State of Alaska
Department of Fish and Game
Sportfish Division

Nomination Form
Anadromous Waters Catalog

Anadromous Waters Catalog Number of Water Body 259-25-10030-2001

Name of Water Body Unnamed Tributary Capelin Creek

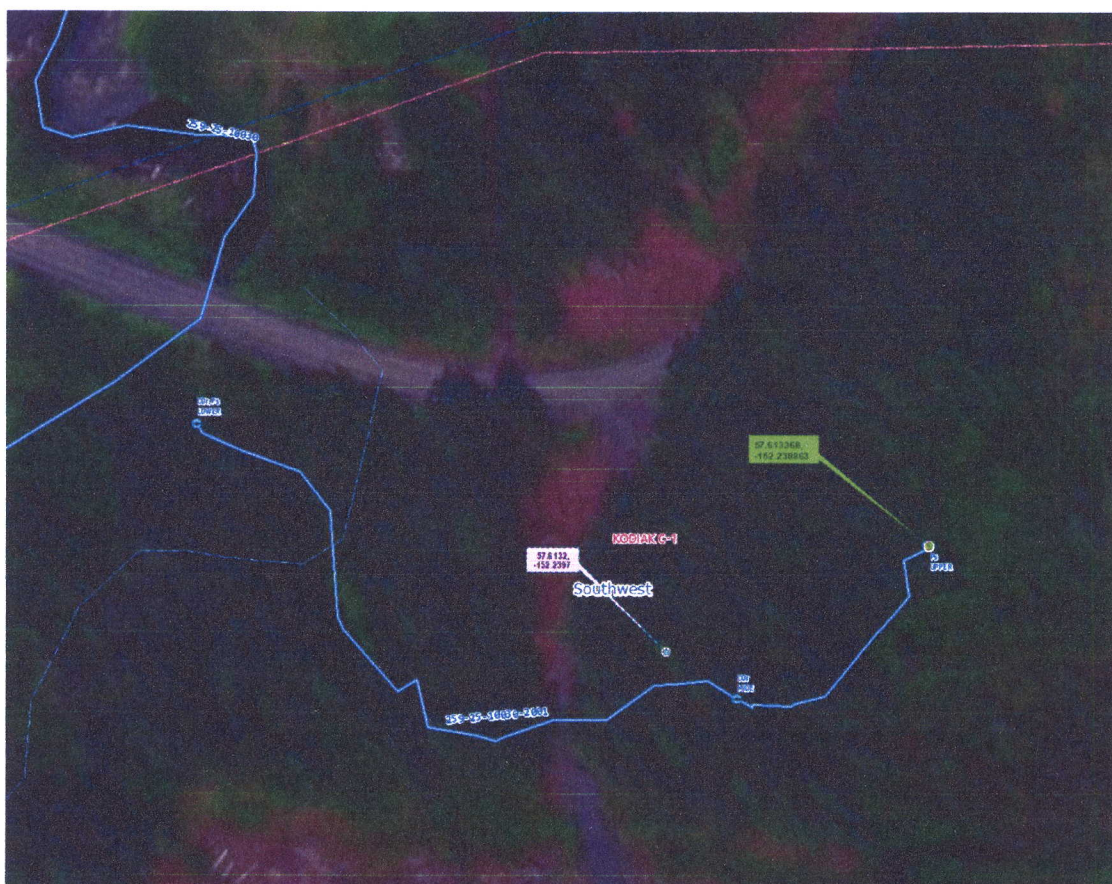
I wanted to confer with you about the location of the barrier. The lat/long in Nom #24-539 does not plot just above the current upper extent (see image below, pink point and call-out is that lat/long). This stream didn't exist before your 2013 nomination (#13-165) and it looks to me like you provided J Johnson with a gps line and points? Unfortunately I don't have data saved before 2015, but I'm assuming the barrier should be just above the current upper extent? The green call-out box is a more accurate lat/long for that location. Can you confirm my interpretation of this nom and that it's consistent with your intentions with Nom #24-539?

Yes, the green box is the correct barrier location. The one I provided was taken from an image. The lower start point is where it flows into Capeline Creek. Is it possible to correct Capelin Creek so they match up? The Kodiak Island Borough is planning on developing the adjacent lands, so I want to make sure they know the upper extent of specified anadromous waters.

Figure 2

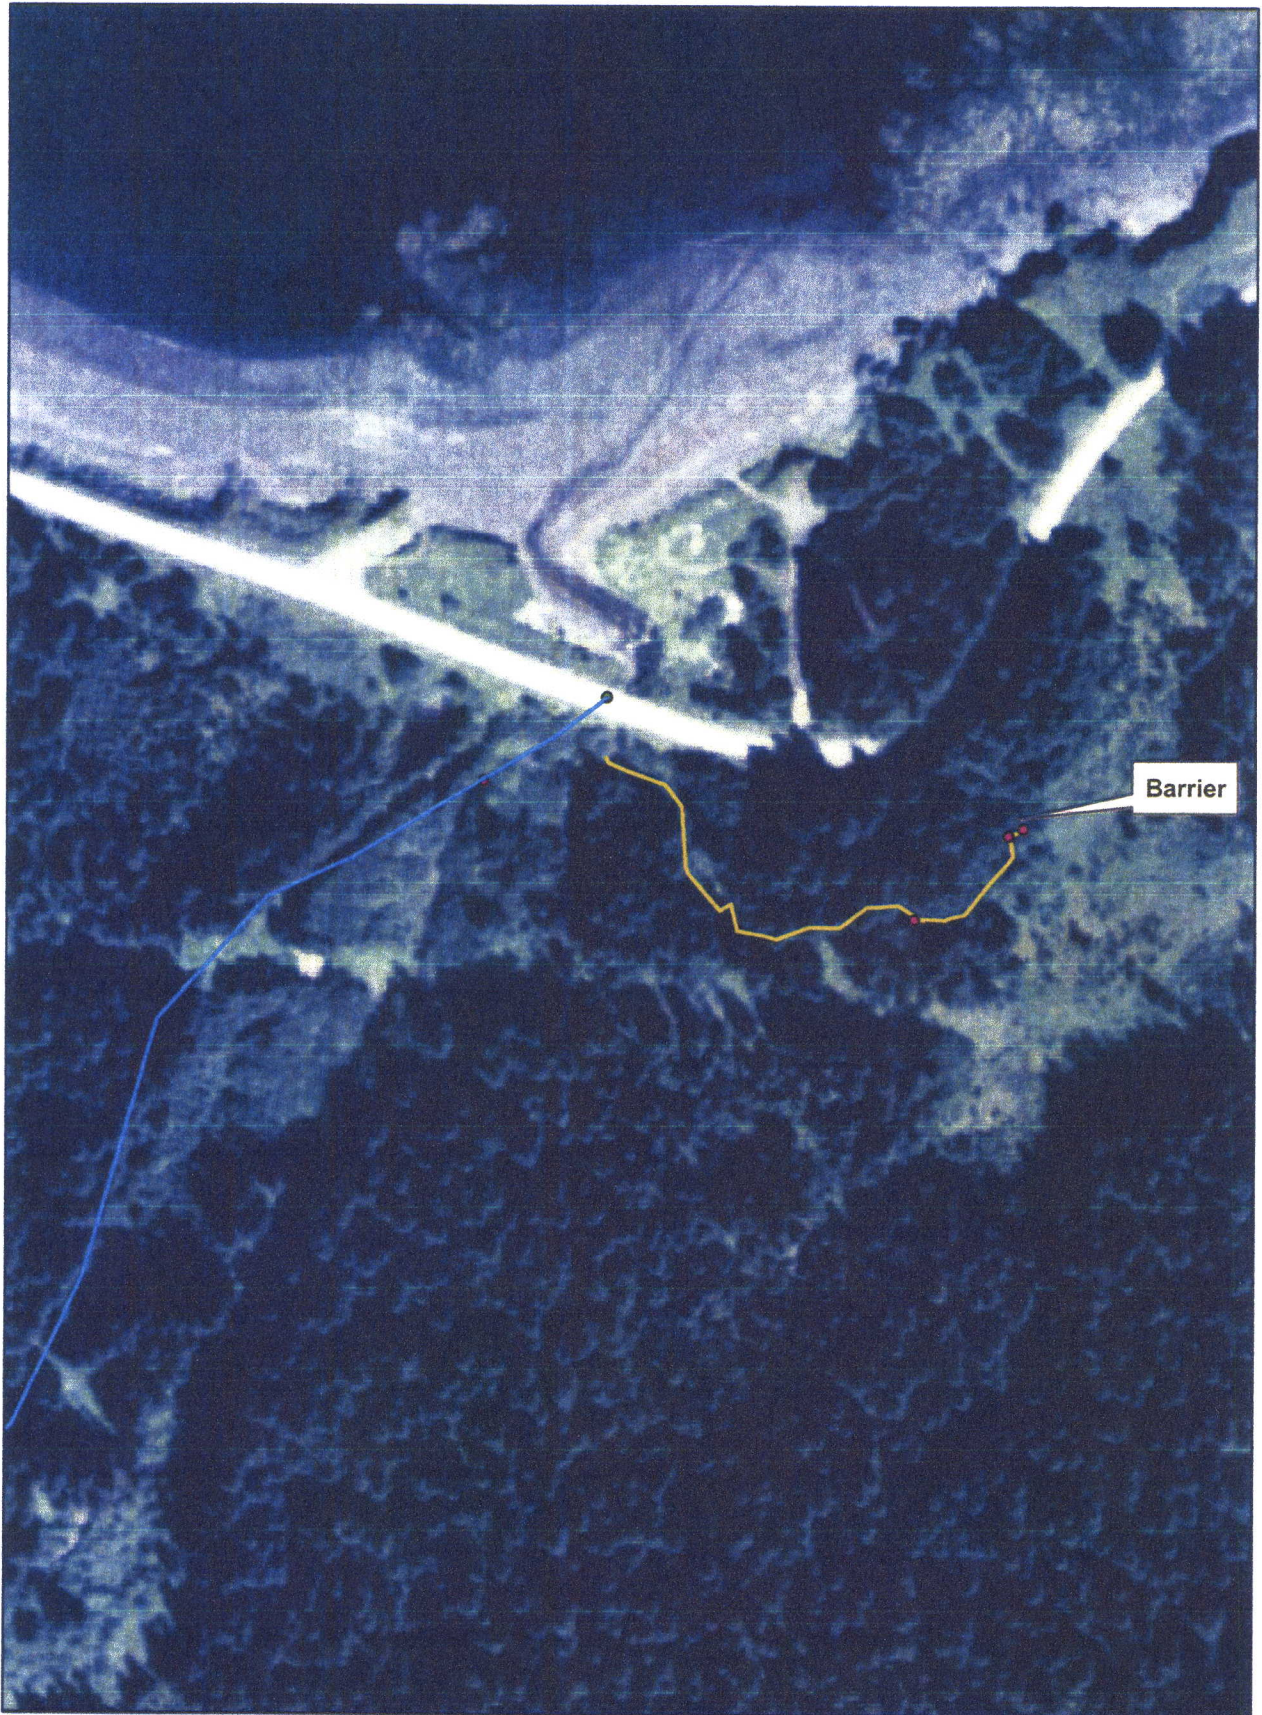
We drove to the mouth of Capelin Creek and observed about 3,000 adult pink salmon in the lower reach of the stream (Figure 2). We located an unnamed tributary stream adjacent to the inlet of the culvert, located under the Chiniak Highway. We walked upstream in the tributary about 650 linear feet until we located a 4-foot high barrier. We observed adult pink salmon spawning and juvenile coho salmon rearing in the stream below the barrier. The unnamed stream will be nominated to the Anadromous Waters Catalog.
